## Report ABPC/18/14

**To: Aldington and Bonnington Parish Council.**

**Subject: Defining Village Confines**

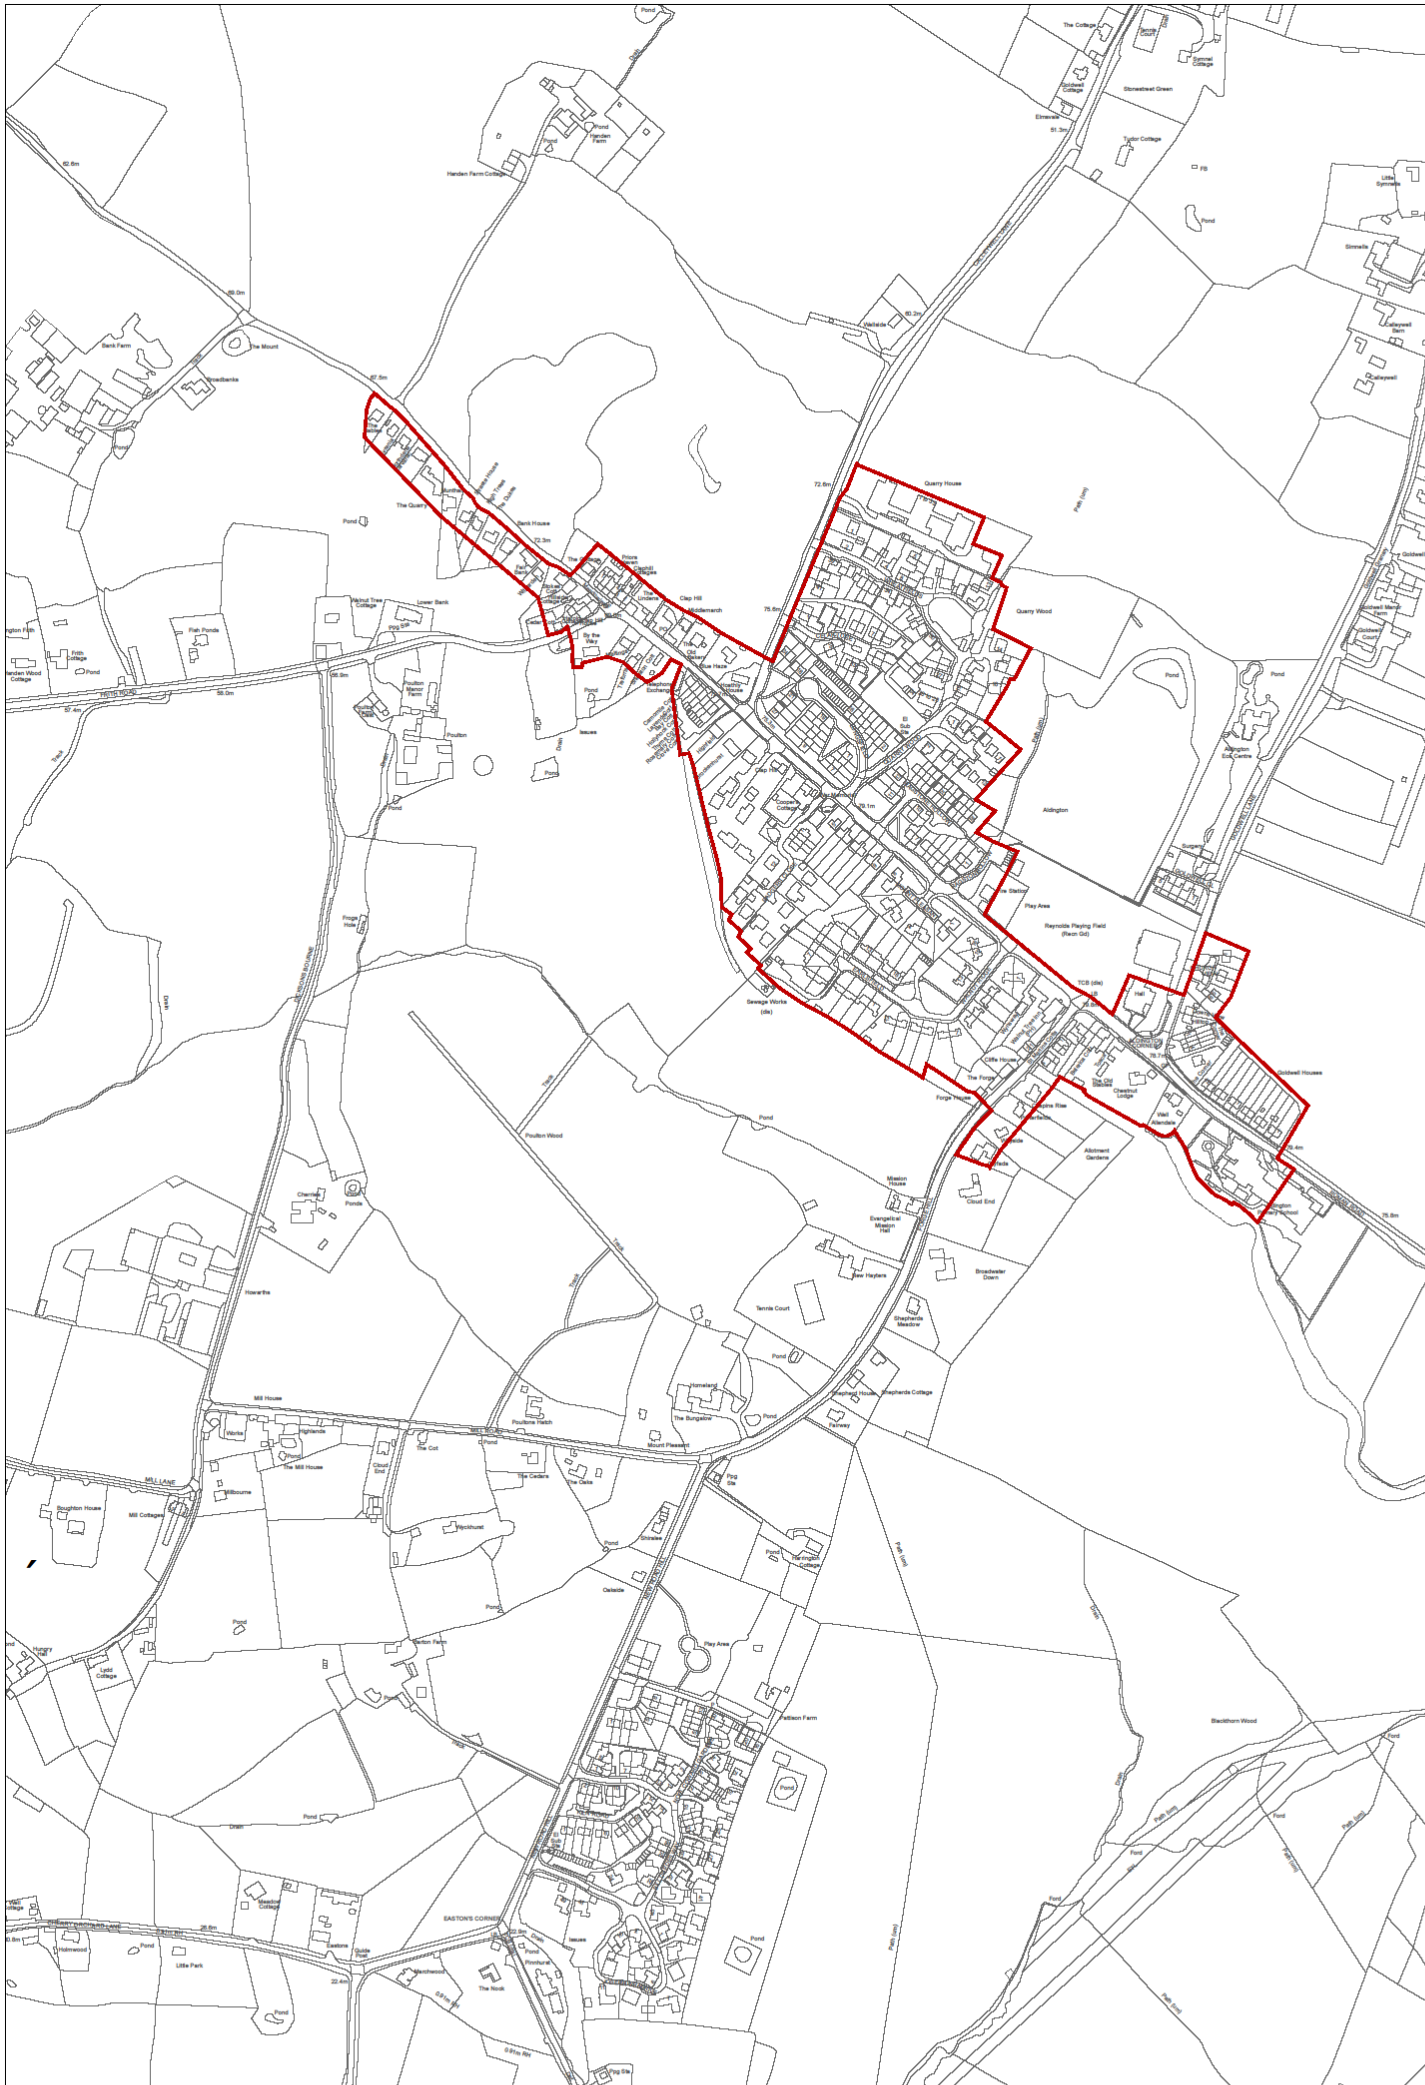
- Not in agreement with the confine – In some places it seems arbitrary. Also drawing the line in whatever position becomes somewhat academic if development is to be permitted outside the line.

- Not in agreement with the confine – I do not consider that HOU5 can be considered windfall. Frith Road/Clap Hill is the natural boundary West of the village to the West Goldwell Lane and Forge Hill are the natural boundary.

- Not particularly – it would seem that the red line denotes an area in which present development and any future development are/is open to interpretation and depending on who you are and what you own will be treated in a conflicting way. i.e. ABC/KCC land has been developed far beyond what is acceptable in size. i.e. impact on infrastructure/roads/light pollution. Surely the red line should now only permit rebuilds/extensions, not another 30+ houses.

- Not in agreement with the confine – Bank Road should be excluded. Forge Hill below the allotment access should be excluded.
- Not in agreement with the confine – As Quarry House was an exception I think it should be excluded.

- Not in agreement with the confine – the confines should not include Bank Road. Regarding Forge Hill the confines should end at the entrance to the allotments.

- Not in agreement with the confine – no comment
- Not in agreement with the confine – it may allow them to build up to people's gardens. There should be no more development in Aldington.

- Not in agreement with the confine – the infrastructure in and around Aldington cannot withstand and more development inside or outside of the proposed area.

- Not in agreement with the confine – I am totally against and more development in Aldington, when is the planning department members of ABC going to listen to the local residents who have first hand experience of infrastructure problems, the confine lines drawn by a representative of ABC are just that LINES.
